HISTORIC AND DESIGN REVIEW COMMISSION

HDRC CASE NO: 2022-469
ADDRESS: 304 SADIE ST
LEGAL DESCRIPTION: NCB 733 BLK 5 LOT 1 AND 2
ZONING: RM-4, H
CITY COUNCIL DIST.: 1
DISTRICT: Lavaca Historic District
APPLICANT: Henry Tijerina/Tijerina Construction LLC DBA Protec Services
OWNER: GONZALEZ CARLOS OMAR & SELSABEEL A
TYPE OF WORK: Fenestration modifications
APPLICATION RECEIVED: August 31, 2022
60-DAY REVIEW: Not applicable due to City Council Emergency Orders
CASE MANAGER: Claudia Espinosa

REQUEST:

Sheet Name
 ELEVATION SOUTH & EAST - DEMO

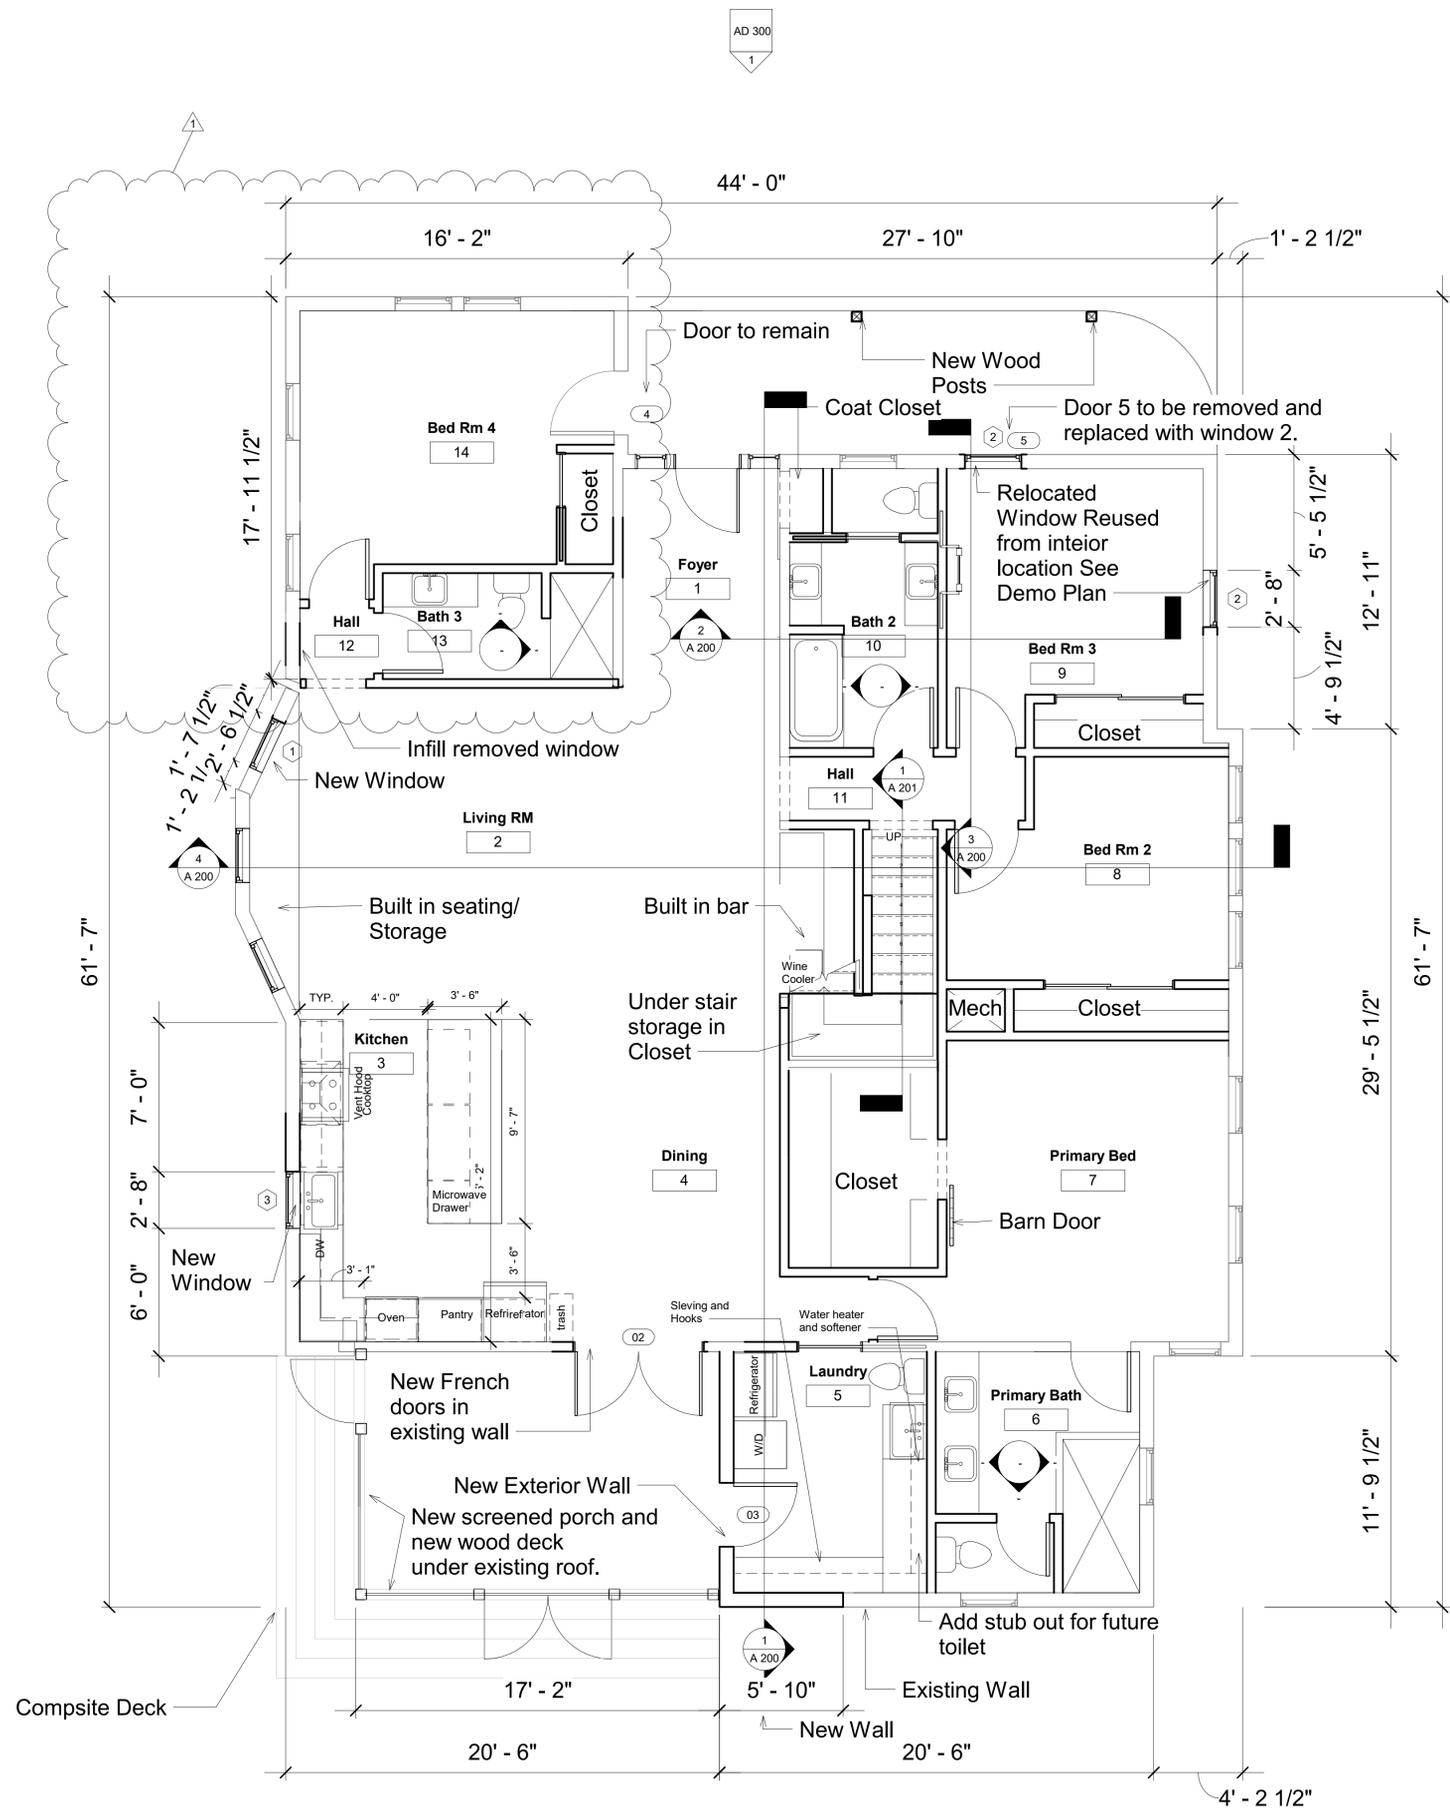
- c. FENESTRATION MODIFICATION: SOUTH FAÇADE – The applicant is requesting to remove an existing, rear window on the south façade beneath the gabled roof and install a transom window. Given this window’s location at the rear of the house, and evidence that an original, larger opening was once at this location, staff finds its modification to be appropriate provided that the width of the original opening be maintained at its current location.

- d. FENESTRATION MODIFICATION: EAST FAÇADE – The applicant is requesting to remove an existing, side window on the east façade beneath the gabled roof and install a transom window. Given this window’s location near the rear of the house, staff finds its modification to be inconsistent with the Guidelines 6. A.i.

- e. FENESTRATION MODIFICATIONS: EAST FAÇADE – The east façade has three, non-original windows that located toward the rear of an enclosed wrap around porch. The applicant has proposed to modify this opening by eliminating one of the three openings and replacing the existing, damaged windows with windows salvaged from the rear wing. The sizes of the salvaged windows differ from what is existing. Given that the condition is not original and the proposed alteration retains a traditional fenestration pattern, staff finds this to be appropriate. However, staff does not find removal of one of the proposed salvaged windows to be appropriate. If the rear wing windows are not approved for reuse, then a new one-over-over wood window would be appropriate at this location.

- 1. Staff recommends approval of item #1, the removal of an existing rear window and the installation of a new window with the following stipulations:

- i. That the original width of the window opening be maintained.
 - ii. That a wood or aluminum clad window be installed that features a sash profile.

- 2. Staff does not recommend approval of item #2, the removal of the existing, side window and the window opening modification based on finding d. Staff recommends that this window opening be preserved as it exists.

- 3. Staff recommends approval of item #3, modifications to the non-original fenestration profile on the east façade with the following stipulations:
 - i. That is the rear windows noted in findings c and d are not approved for reuse, the applicant install a new, one over one wood window. This window should be consistent with staff’s standards for replacement windows and should be submitted to OHP staff for review and approval.
